Medical Device Alert

MDA/2019/038

Syringe driver pumps: T34™ 3rd edition models only – stop using the pump until updated instructions for use and BodyComm™ V3.0 software are released

Images showing the difference between 2nd and 3rd edition pumps:

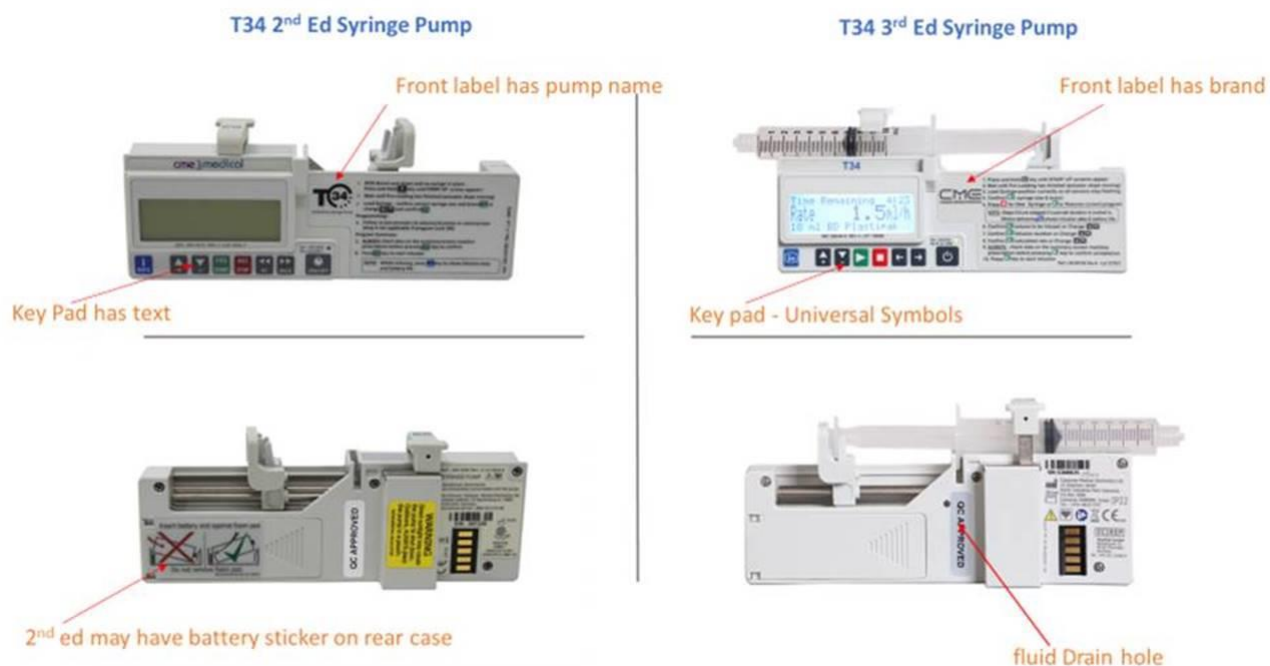
In April 2018 the manufacturer released an updated version of the T34 syringe driver pump, referred to as the 3rd edition.

This was updated primarily to ensure compliance with version 3.1 of the medical electrical equipment and systems standard IEC 60601-1.

- errors and inconsistencies in the instructions for use
- [incompatibility of the BodyComm™ 88-102 software with 3rd edition pumps](#)
- [changes to battery life](#)
- use implications due to change in device interface

- BD/CME will contact you directly regarding the BodyComm V3.0 software and when the updated version of the IFUs are available.
- Once you receive the updated IFUs, make sure users are aware of the revised intended use of the pump and other performance specification changes from the previous, 2nd edition, T34 syringe driver pump. BD/CME offers training if required.

- Pumps can be returned to service once the updated IFUs have been received and there is a system in place for the configuration of 3rd edition T34 pumps to only be used with V3.0 BodyComm software. Note: previous versions of the BodyComm software (88-102) are not compatible with 3rd edition T34 pumps (see device details section).
